# Preliminary Change Request for the SNS 1.3 GeV-Compatible Ring

BNL/SNS TECHNICAL NOTE

NO. 076

May 4, 2000

Figure 5: Layout of the proposed 1.3 GeV-compatible lattice for the Spallation Neutron Source ring.

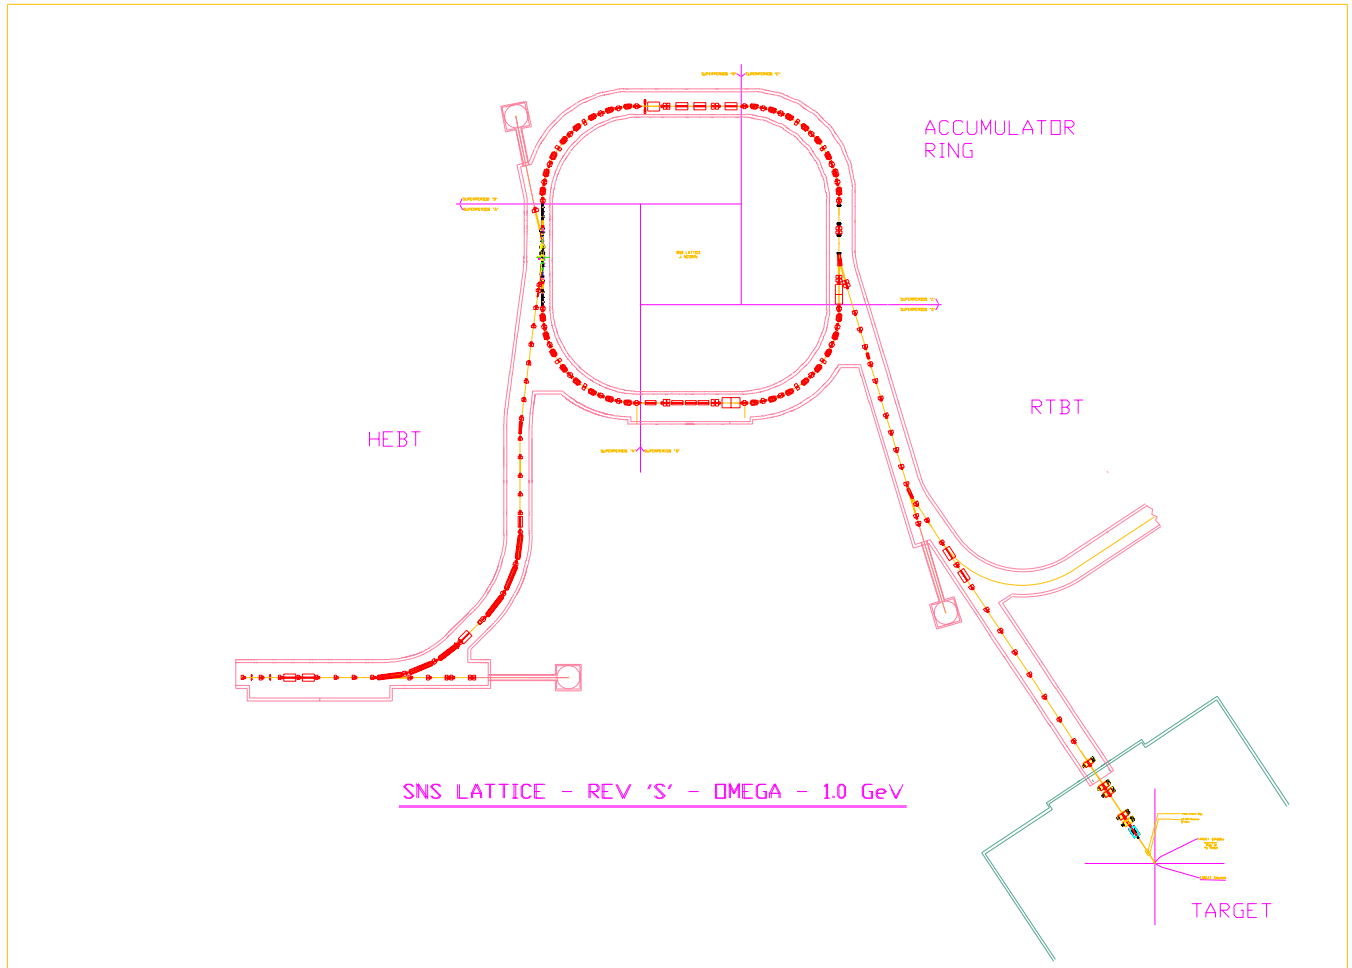
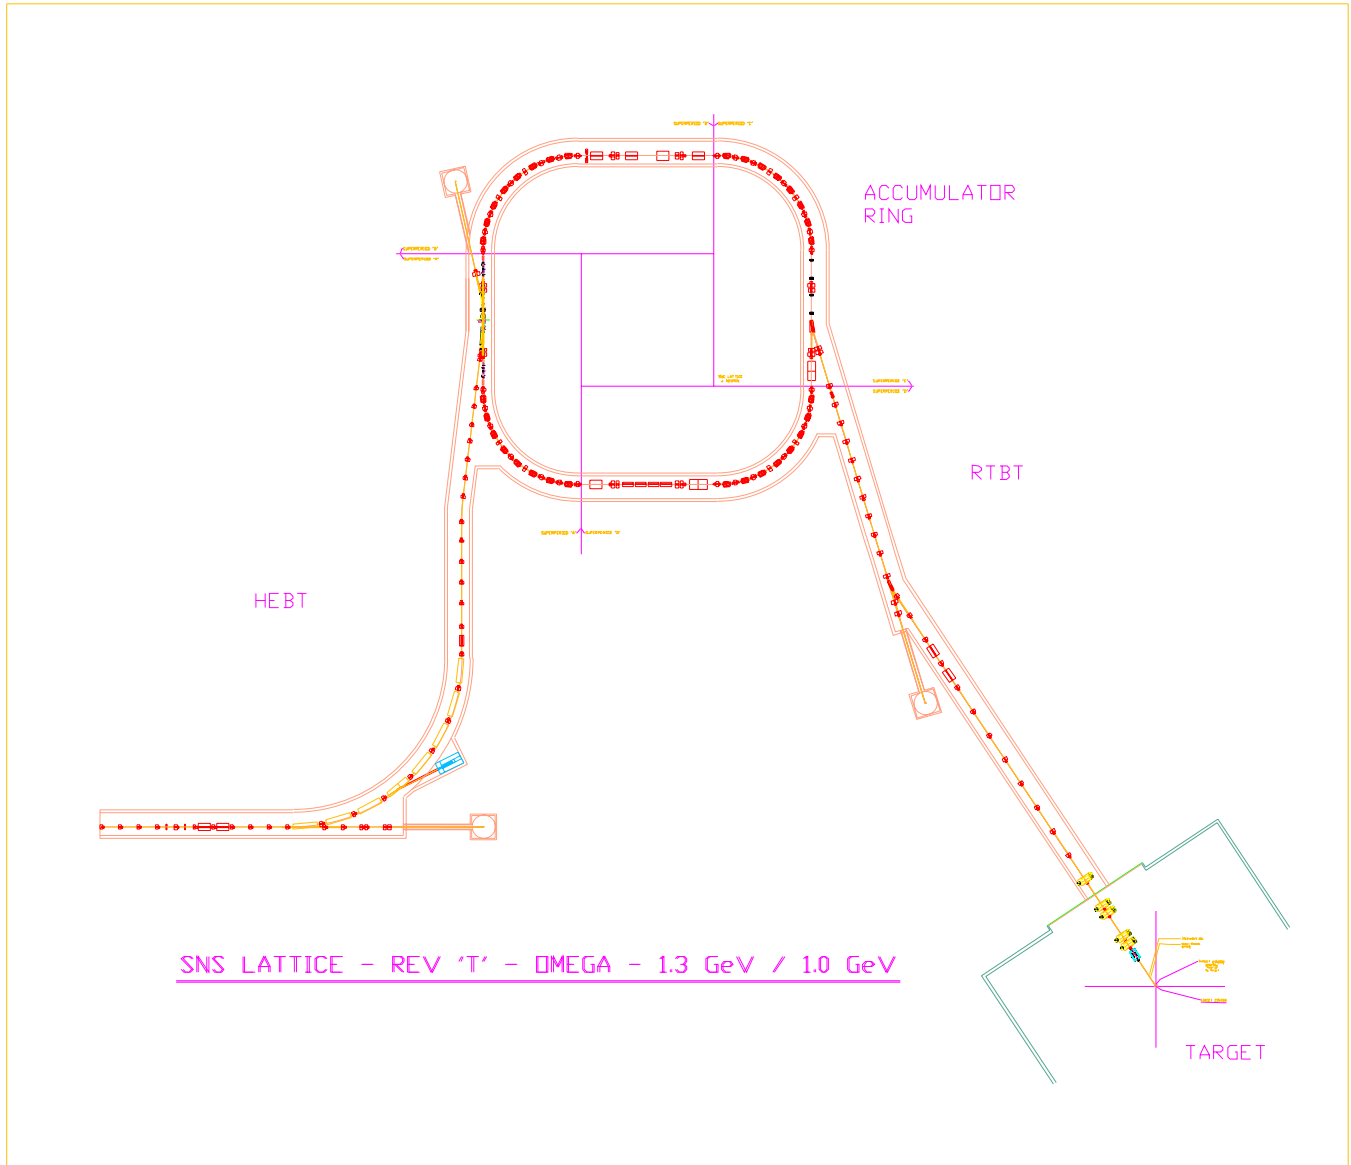
The proposed layout is again in omega configuration, as shown in Figure 5. The bending radius of the  $90^\circ$  achromat bend of the HEBT is increased due to the reduced dipole field. The HEBT length becomes 162 meters, 25 meters longer than the original. The length of the RTBT is assumed unchanged at 150 meters.

The general configuration of HEBT, ring, and RTBT remain the same. The length of HEBT line is increased by 25 m. The length of RTBT line is assumed to be the same, provided that the target can be relocated about 10 m from the original site towards the ring.

Figure 6: Schematic layout of the proposed 1.3 GeV-compatible SNS ring.

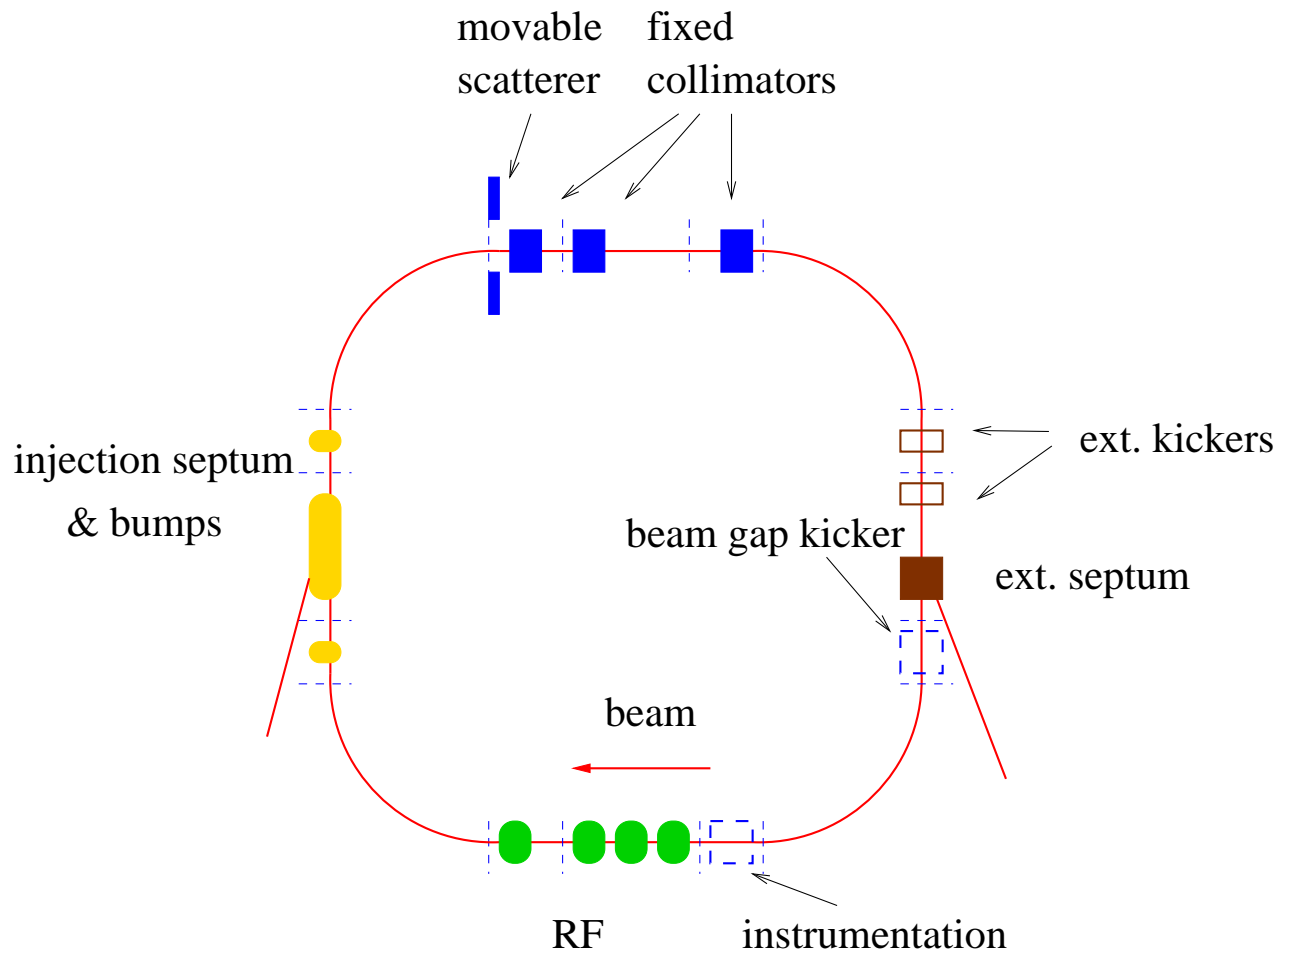
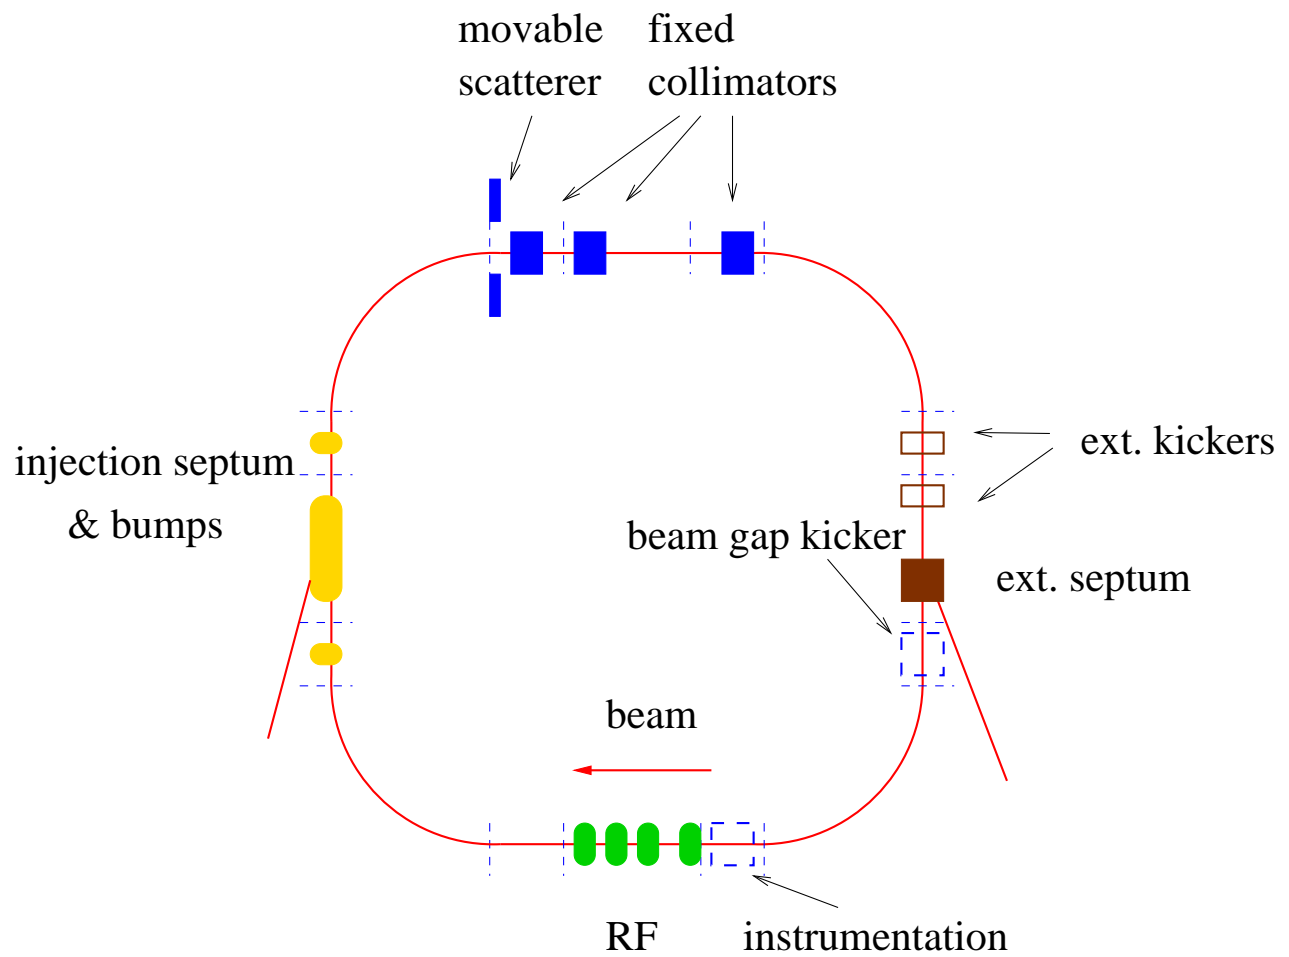
Figure 6 shows the schematic layout of the ring. The four straight sections are mainly designed for beam injection, beam collimation, extraction, and RF systems. All four RF cavities (three  $h = 1$ , one  $h = 2$ ) are located in the same drift space. Figure 7 shows the layout of the lattice magnets (dipole, quadrupole, sextupole, and correctors) in one of the four lattice super-periods. Dipole correctors in both the arc and straight sections are used for misalignment closed orbit correction. The sextupoles in the arc sections are used for chromaticity adjustment, off-momentum optics matching, and momentum aperture improvement. The multi-layer correctors in the straight sections are used for resonance corrections.

Each of the 4 lattice period contains a straight section that has one 12.50 m and two 6.85 m drift spaces. The total straight section length is about 104.8 meters. For each drift space, the “overhead” taken by correctors, BPMs, vacuum pumps, bellows, flanges, etc. is about 1.6 meters. The total usable length is about 85 meters. Each period has 5.2 m – 11 m – 5.2 m structure. The total unclaimed drift space is adequate for an upgrade to a 1.3 GeV machine.

Figure 16: Extraction layout and closed orbit of the 1.3 GeV-compatible ring. The two kickers marked with blue color are reserved for 1.3 GeV operation.

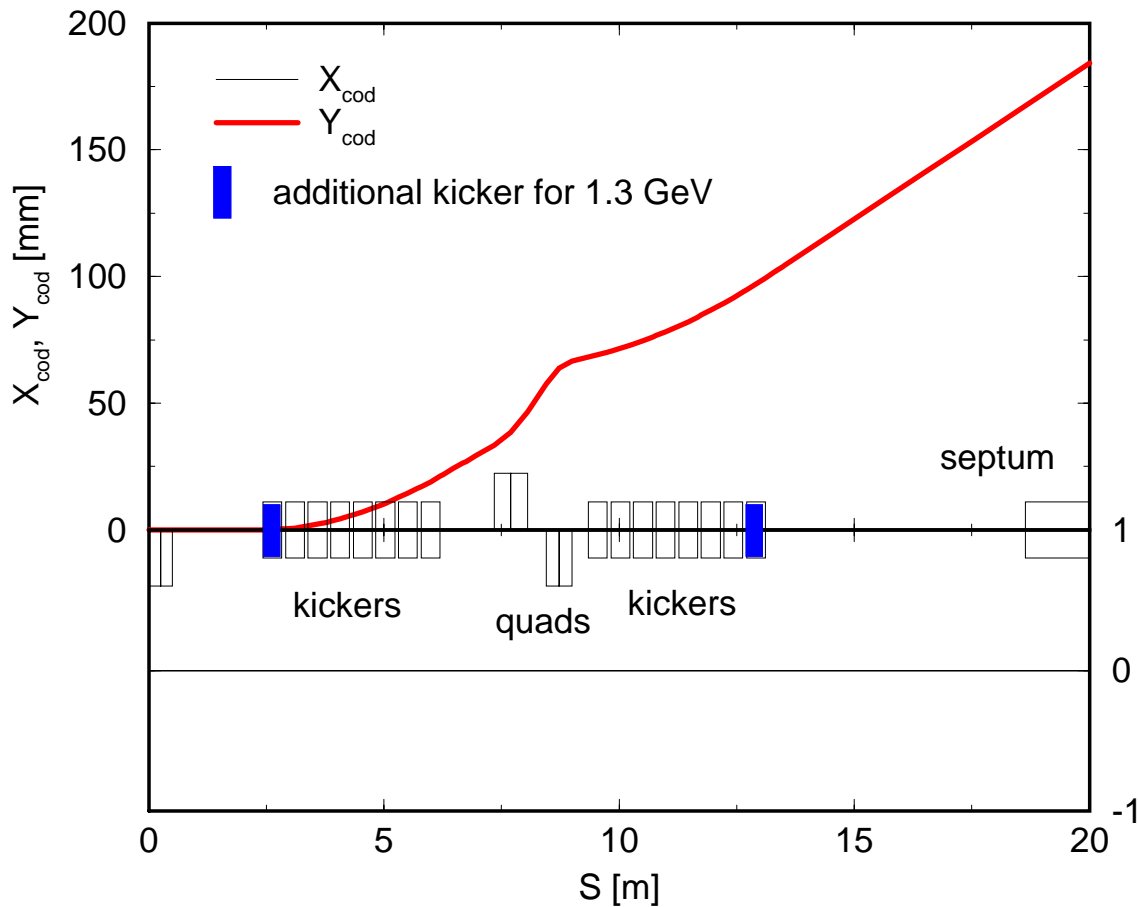
Space is reserved for the addition of two extra kickers for 1.3 GeV operation without changing the location of the existing 14 kickers.

The number and strength of extraction kicker modules remains the same, but the dimension is increased. The length of extraction Lambertson septum is increased from 2.1 to 2.4 m. Space is reserved for addition of two kicker modules for 1.3 GeV operation.

Figure 17: Horizontal schematic layout of the beam injection region of the proposed ring operating at 1.3 GeV.

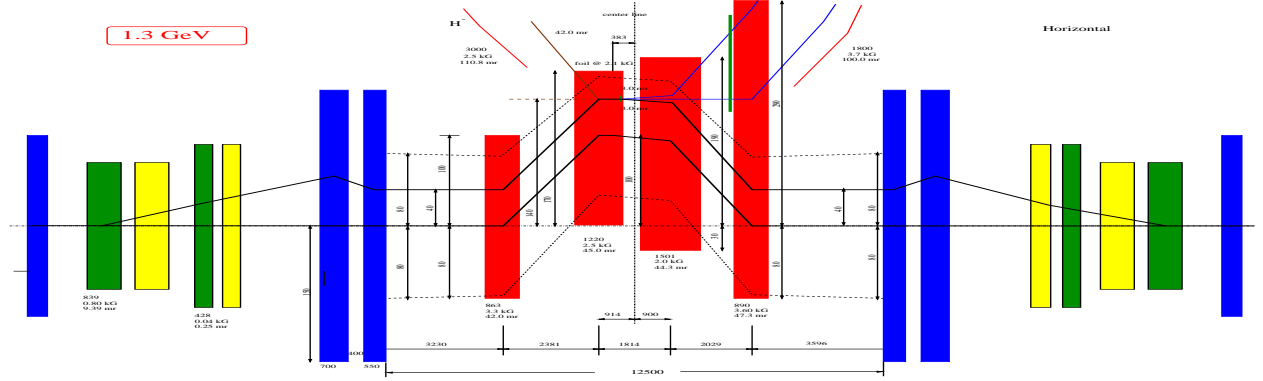
Comparing with 1 GeV operation, for 1.3 GeV operation two injection dipoles need to be

replaced by approximately 40% longer units operating at reduced (20%) fields, as shown in Figure 17. The location of the foil mechanism is also changed. Major parameters for the injection magnets are listed in Table 22. The 2.5 kG field of the magnets INJSEPTM1 and
